**ATTACHMENT B  
PROPOSED CHANGES TO THE  
LICENSE/TECHNICAL SPECIFICATIONS**

**LASALLE COUNTY STATION**

**MAIN CONTROL ROOM ATMOSPHERIC CONTROL SYSTEM RADIATION  
MONITORING INSTRUMENTATION TECHNICAL SPECIFICATION**

TITLE (4) Inadequate Review of Modification of Main Control Room Atmospheric Control System  
Radiation Monitoring Logic Results in an Unreviewed Safety Question

UNIT 1(2) MCRACS RADIATION MONITOR TRIP LOGIC PRIOR TO INSTALLATION OF  
MODIFICATION M01-88-003A(B)

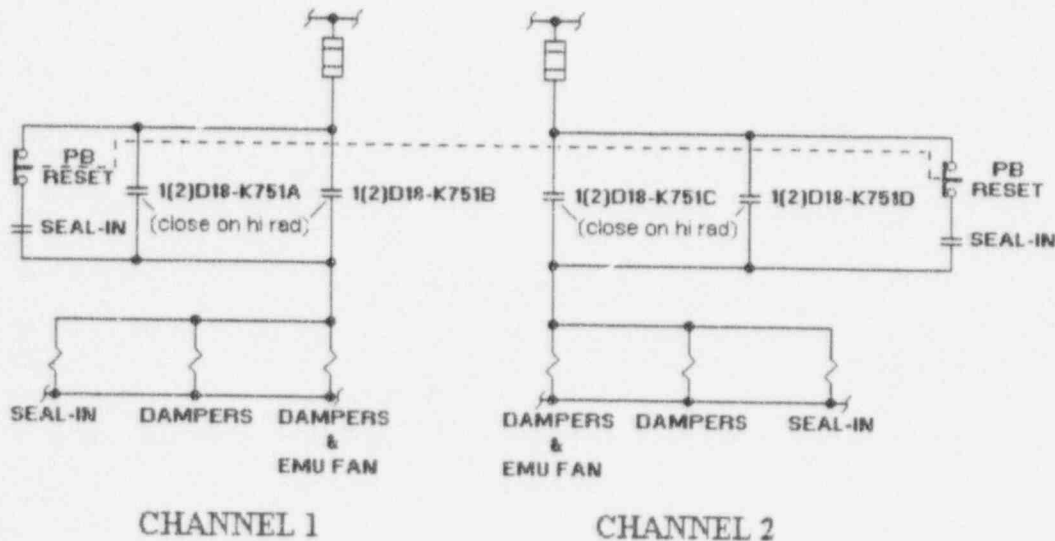
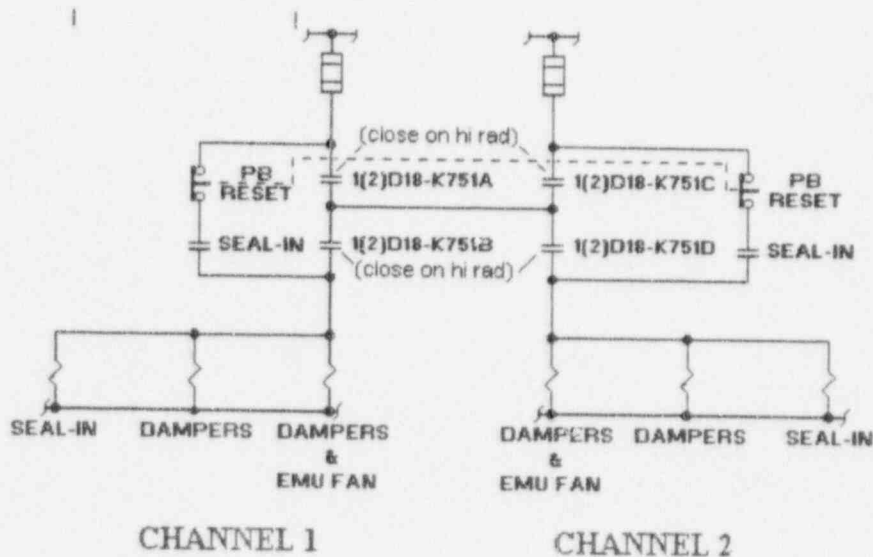
On July 13, 1993, and July 26, 1993, modification of Unit 1 and Unit 2 Main Control Room Atmosphere Control System (MCRACS) Radiation Monitoring System (PR/VC) [IL] logic was made to prevent spurious Engineered Safety Features (ESF) actuations. Prior to installation of the modifications, the logic for initiation of the Emergency Makeup Mode due to High Radiation levels in the ventilation intakes consisted of four radiation monitors per intake divided into two channels to provide a one out of two taken once trip logic. See Attachment A. Due to this trip logic, a spurious trip of any one of the radiation monitors caused an ESF actuation. To eliminate spurious ESF actuations the modifications changed the trip logic for each Unit to require actuation of two monitors per channel to initiate the ESF actuation. See Attachment B.

The root cause of the inadequate safety evaluation for the modifications performed in 1993 was that LaSalle County Station failed to recognize that damper isolation for the control room ventilation air intakes is not functionally redundant. Hence, the modified design would have allowed a single failure to result in the failure to isolate one train.

Due to the one-out-of-four logic and the very low setpoint (2.5 mR/hr), the system was subject to spurious actuations. In 1989, LaSalle County Station investigated several modifications to the system to reduce the occurrence of spurious actuations. One proposal was to revise the actuation logic to require a signal from minimum of two radiation monitors in order to actuate the emergency mode.

In June, 1992, the AE was directed by LaSalle County Station to revise the design to incorporate a "limited two-out-of-four" logic. The reason given for the change was to allow the removal of two monitors at a time from service for ease of maintenance. The change also reduced the complexity and expense of the design change.

The AE incorporated the request and the revised design was issued in September, 1992. This design no longer met the channel redundancy requirements in the design basis. This was not recognized during the review and approval process as the new design appeared to be a basic simplification of the design change which had been proposed and reviewed numerous times since 1990.

1. A modification will be developed to correct the installed design. The original channel separation and redundancy will be restored. The revised design will meet the single failure criterion of the design basis.
2. The Technical Specifications will be revised to conform to the design and to eliminate confusion in the wording of the action statement.
3. An ongoing detailed system design review of the MCRACS is already in progress as a result of previous concerns as identified in LER 96017.
4. A review of other modifications to the MCR Ventilation System which could affect the single failure criteria as it applies to the MCR Isolation Dampers and Control Circuitry will be conducted.
5. A review of the changes which removed FSAR drawings from the UFSAR to ensure that the information contained on the drawings is adequately referenced in the UFSAR for subsequent Safety Reviews.
